Docket No. 50-331

SUBJECT: MEETING WITH IOWA ELECTRIC LIGHT AND POWER

Duane Arnold Energy Center

In their letter dated December 2, 1986, the NRC staff requested additional information pertinent to their review of Revision 7 to the Inservice Testing (IST) Program for Pumps and Valves dated December 31, 1985. The following information provides responses to the NRC questions.

Figure 1.

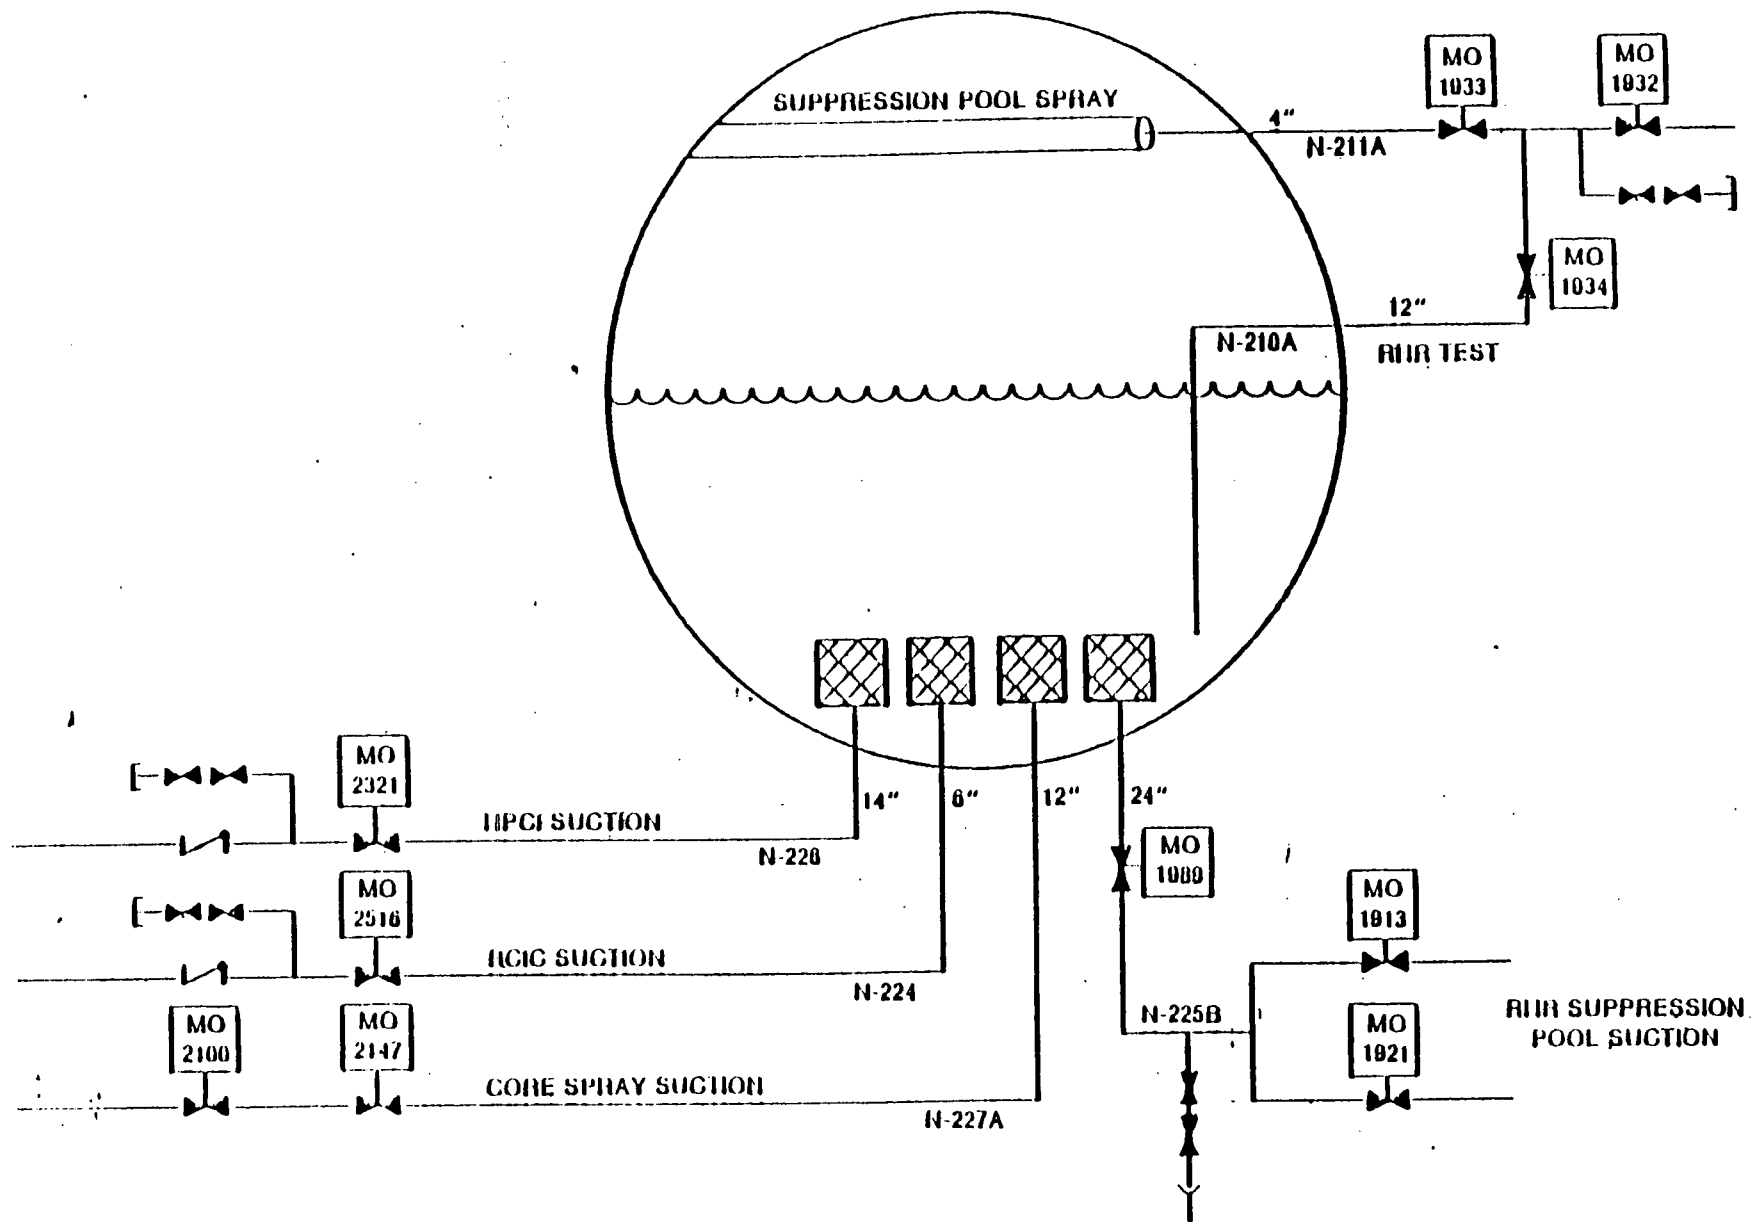
The piping configurations of concern are presented in Figures 1 and 2. Figure 1 shows the HPCI, RCIC, and core spray suction lines and one loop of the suction, suppression pool spray, and RHR test lines. Figure 2 shows one loop of LPCI injection, RV head spray, and containment spray. As can be seen in Figure 1, the HPCI, RCIC, core spray, and RHR suction lines are isolated from the containment atmosphere by the water level in the suppression pool. Since these lines are continuously water filled in a post-accident condition,

The isolation valves are not relied upon to prevent the escape of containment air to outside atmosphere; therefore, Type C testing is not required by Appendix J. Similarly, because the RER test line terminates below the level of the pool, its isolation valve is also isolated from containment atmosphere, and Type C testing of this line is not required.

Figure 2.

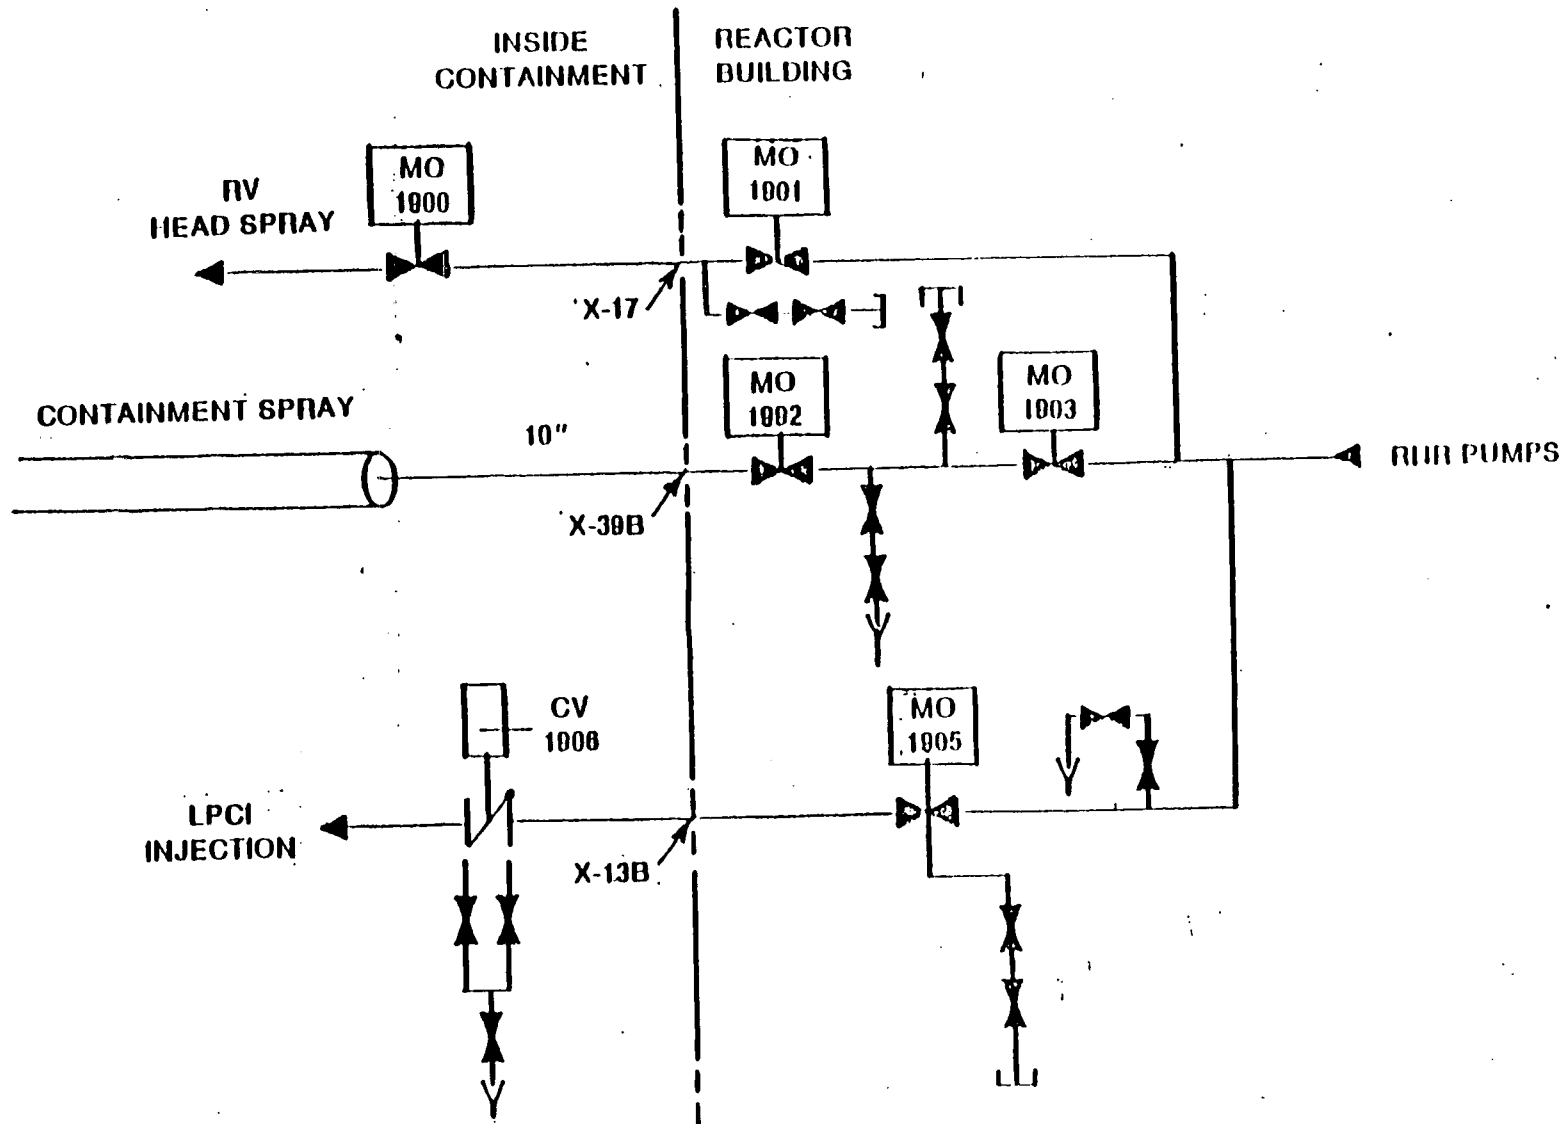
The LPCI injection line will be normally open and filled with water at a pressure greater than containment accident pressure as soon as safety injection is initiated. Furthermore, should valve MO-1905 (Figure 2) fail to open, the valve will be water sealed by RER water at pump head pressure, and no single active failure can cause a loss of this pressure. Since MO-1905 is a gate valve, the water pressure will unseat the upstream valve disc and pressurize the valve packing and body-to-bonnet seal area with water. Consequently, there is no path for containment air leakage to the atmosphere through this line, even in the case of air leakage past the seat of check valve CV-1906. Therefore, this line is not a potential source of containment atmosphere leakage and the isolation valves are not required to be Type C tested in accordance with Appendix J.
